### ADDENDUM NO. 1 - OUTLINE AND SUMMARY INFORMATION

Project Name: MAES Lutz Farm Wildlife Fence

PPA No.: 21-0122

Date: Sept 4, 2023

1 DETAIL @ TYP. 18' GATE-ADD 1  
SD1-1 1/2" = 1'-0"

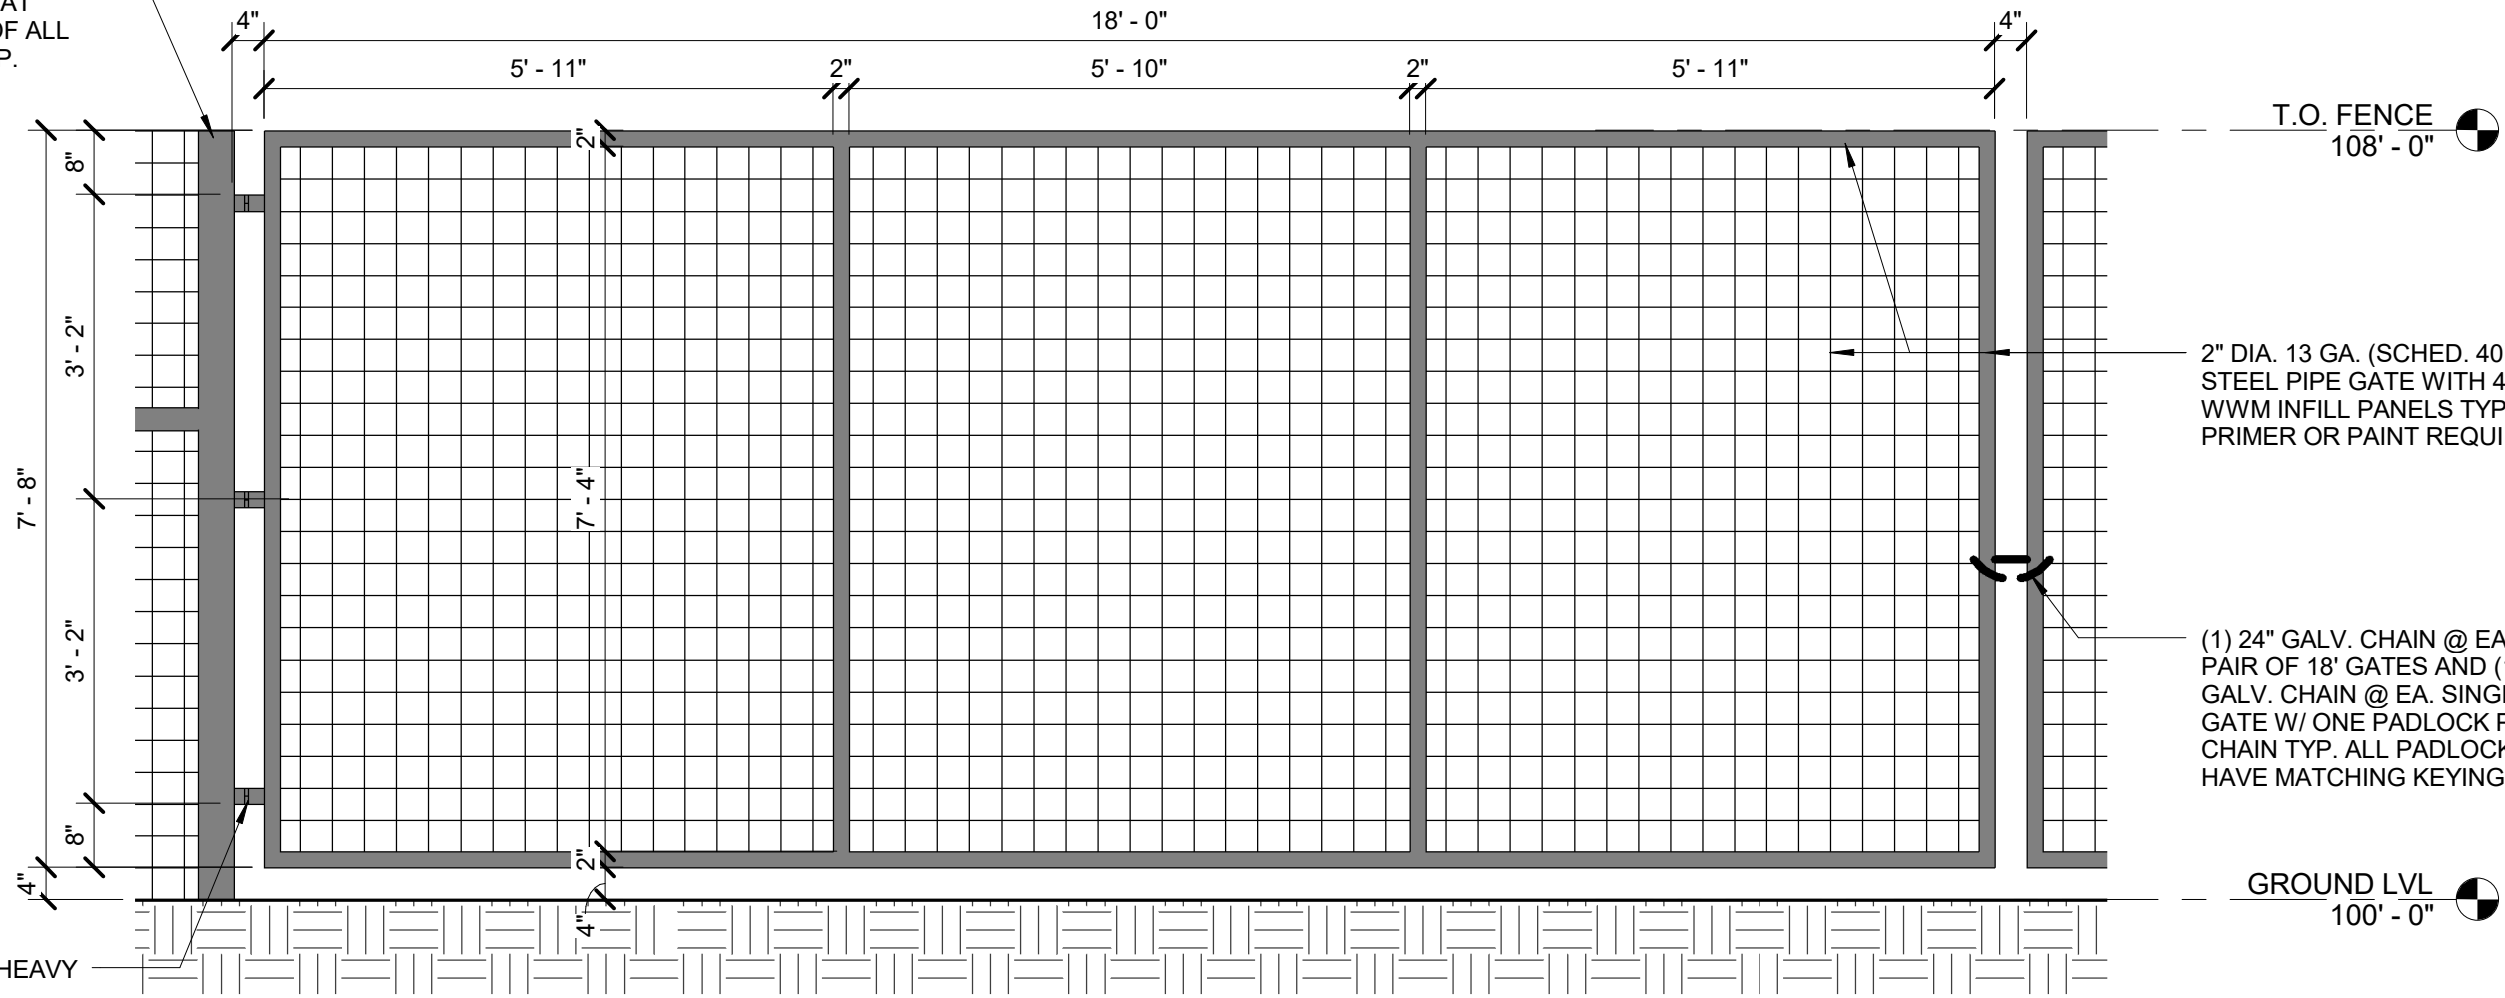
- I. PRIOR APPROVALS – NOT USED
- II. AMENDMENTS TO THE PROJECT MANUAL – NOT USED
- III. AMENDMENTS TO THE DRAWINGS
  - A. SHEET A2-2, DETAILS 3 & 6: REPLACE 18' gate design shown with new gate design indicated on attached supplemental drawings SD1-1.

- B. SHEET A2-3, DETAIL 3: REPLACE 18' gate design shown with new gate design indicated on attached supplemental drawings SD1-1. DETAIL 4: REPLACE man gate design shown with new gate design indicated on attached supplemental drawings SD1-2.

- C. SHEET A2-5, DETAIL 4: REPLACE 18' gate design shown with new gate design indicated on attached supplemental drawings SD1-1 and REPLACE man gate design shown with new gate design indicated on attached supplemental drawings SD1-2.

- E. SHEET A3-1, DETAIL 4: REPLACE 18' gate design shown with new gate design indicated on attached supplemental drawings SD1-1.

4-1/2" DIA. DRILL  
STEM POSTS AT  
HINGE SIDE OF ALL  
18' GATES TYP.
